PARTS & SERVICE NEWS

REF NO.	AT02083
DATE	Jul. 29, 2002

SUBJECT: MODIFICATION PROCEDURE OF DUMPING BODY HEATING EXHAUST PIPE ON HM350, 400-1

PURPOSE: To introduce modification procedure to improve the body heating exhaust pipe on HM350-1 and HM400-1 articulated dump trucks
<For Body heating spec. vehicles only>

1. Introduction

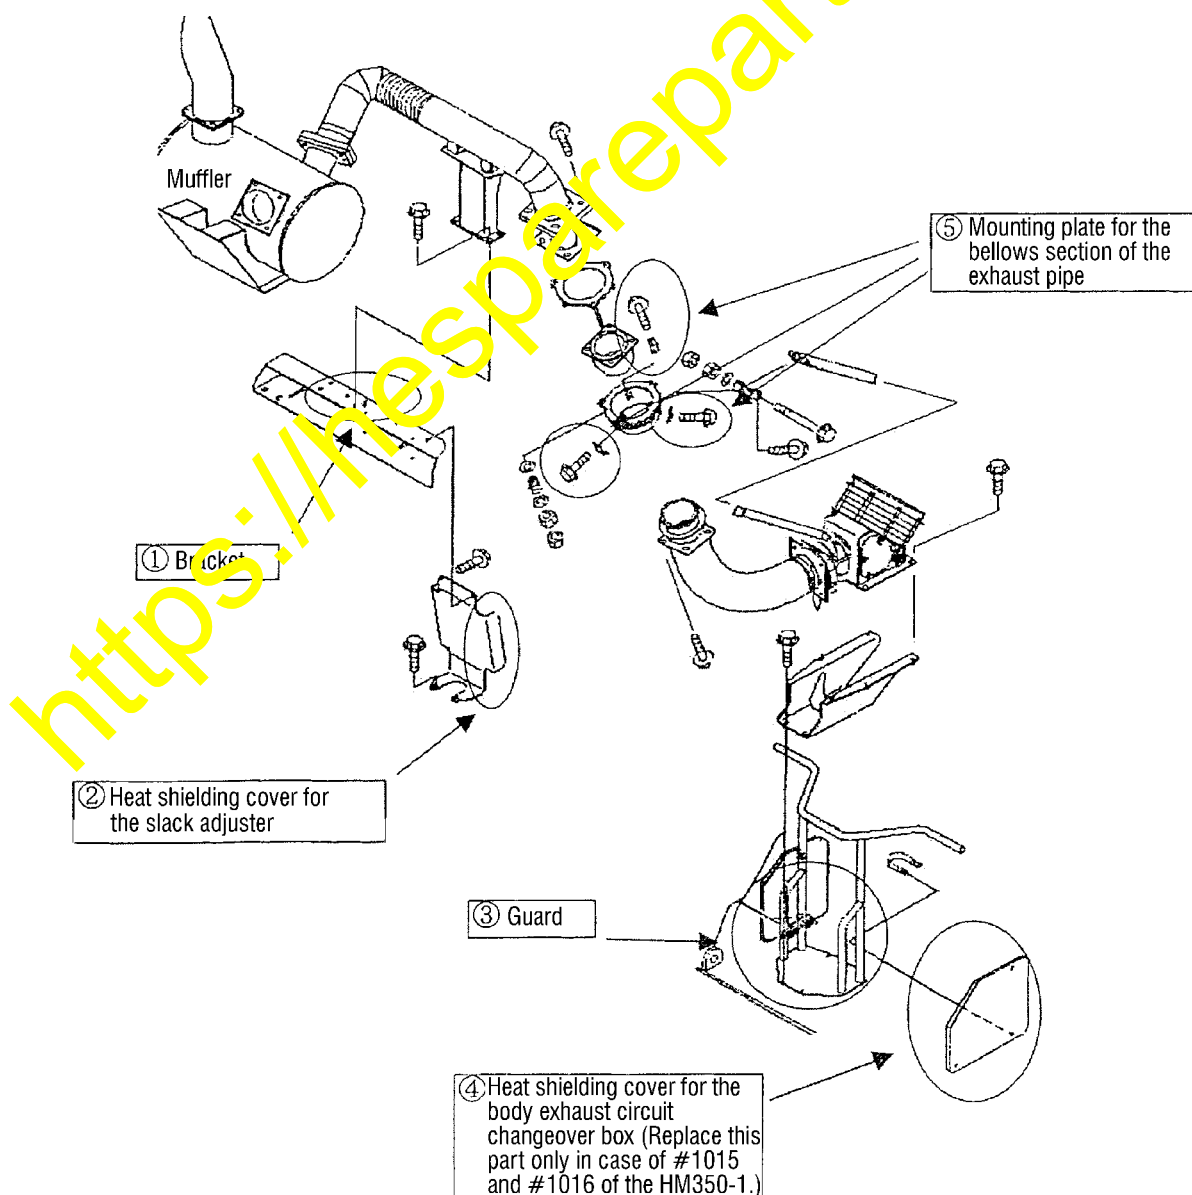
With the HM350-1 and HM400-1 articulated dump trucks, the exhaust pipe connecting between the muffler and the inlet port to the body may cause interference while steering operations are made or when the vehicle body is swayed. To prevent occurrence of the aforementioned interference, implement the modification being introduced in this Service News.

- ① Modification to prevent occurrence of interference between the bellows section of the exhaust pipe and the bracket
To secure necessary clearance from the bellows section of the exhaust pipe by making a cutout in the section of the bracket where interference can occur.

- ② Modification to prevent occurrence of interference between the bellows section of the exhaust pipe and the heat shielding cover for the slack adjuster
To secure necessary clearance from the bellows section of the exhaust pipe by deleting the folded section of the cover where interference can occur.

- ③ Modification to prevent occurrence of interference between the bellows section of the exhaust pipe and the guard
To secure necessary clearance from the bellows section of the exhaust pipe by shortening the height of the column pipe for the guard.

- ④ Modification to prevent occurrence of interference between the bellows section of the exhaust pipe and the heat shielding cover for the body exhaust circuit switching box
To secure necessary clearance from the bellows section of the exhaust pipe by changing the shape of the cover.

- ⑤ Modification to prevent occurrence of loosening of the fastening bolts for the mounting plate for the bellows section of the exhaust pipe
To prevent occurrence of loosening of the fastening bolts by changing the quantity of the mounting plate fastening bolts from 1 bolt to 2 bolts.
